## PIC16C65B Rev. A Silicon Errata Sheet

The PIC16C65B (Rev. A) parts you have received conform functionally to the Device Data Sheet (DS30605A), except for the anomalies described below.

**FIGURE 1:  $\overline{\text{MCLR}}$  EXTERNAL CIRCUIT**

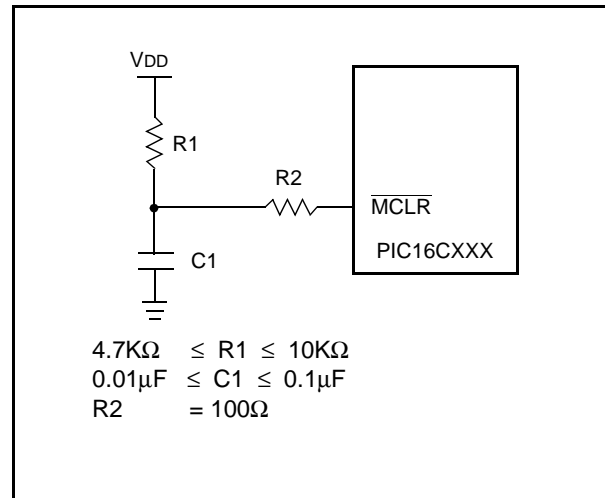
The minimum specification for the  $\overline{\text{MCLR}}$  must be met in order to RESET the PIC16CXXX. If a  $\overline{\text{MCLR}}$  pulse occurs that is less than the minimum specification (parameter #30), improper device operation can occur.

If the minimum specification cannot be met, then an external circuit must be used to insure that any pulse width less than the specification will be filtered before it reaches the  $\overline{\text{MCLR}}$  pin.

A possible circuit is shown in Figure 1. Proper design validation needs to be done to ensure desired operation over the applications operating conditions

**Figure 2: Wake-up from Sleep**

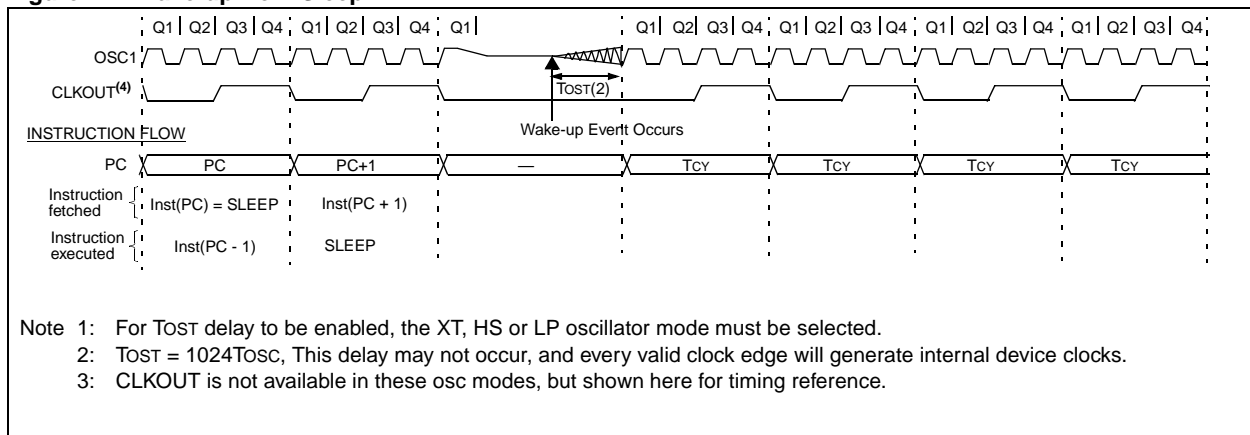
The Oscillator Start-up Timer (TOST) delay may not occur when the device wakes-up from sleep.

Figure 2 shows the start-up of the crystal after the event that causes the device to wake up from sleep mode (as specified in device data sheet). The start-up time (TOST) may not occur.

After the SLEEP instruction, do a software delay of 256 Tcy (same as 1024 TOSC). At the Reset and Interrupt vector addresses, test to see if the device woke from sleep (the  $\overline{\text{TO}}$  and  $\overline{\text{PD}}$  bits), and if the device did wake from sleep, ensure that the total cycle delay is 256 Tcy.

**Figure 3: PIC16CXXX Voltage-Frequency Graph**

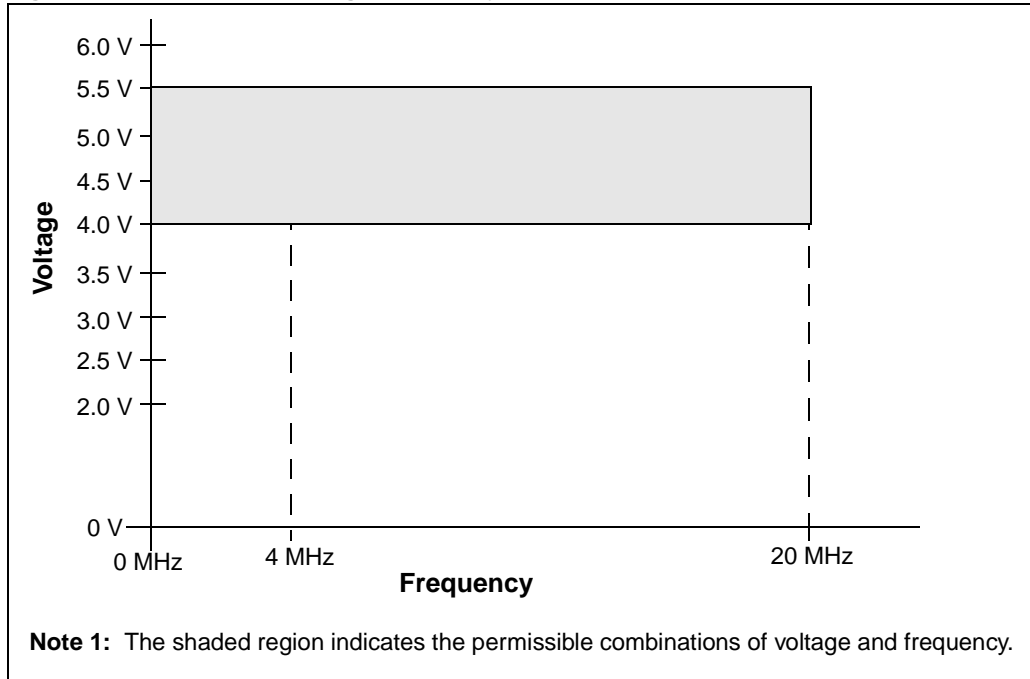
- Figure 3 and Figure 4 are additions to the data sheet to show the area of operation. These figures replace the Cross Reference of Device Specs for Oscillator Modes Table in the Electrical Specification section.

Figure 3 shows the voltage vs. frequency operation for the PIC16CXXX devices. Devices marked with a "-04" operate up to 4 MHz, while devices marked with a "-20" operate up to 20 MHz. The entire shaded region is the valid operating region.

**Figure 4: PIC16LCXXX Voltage-Frequency Graph**

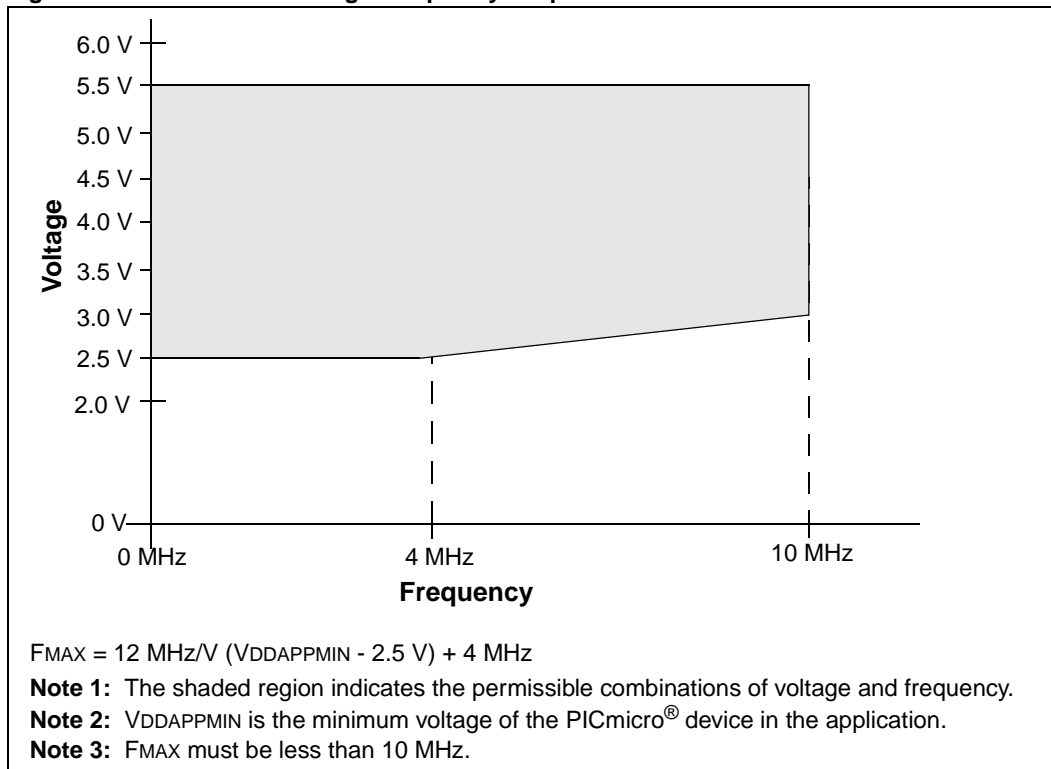
Figure 4 shows the voltage vs. frequency operation for the PIC16LCXXX devices. The devices marked with a "-04" operate up to 4 MHz at the minimum supplied voltage. The devices also operate at a higher frequency (10 MHz) and at a higher voltage (3V). The entire shaded region is the valid operating region.
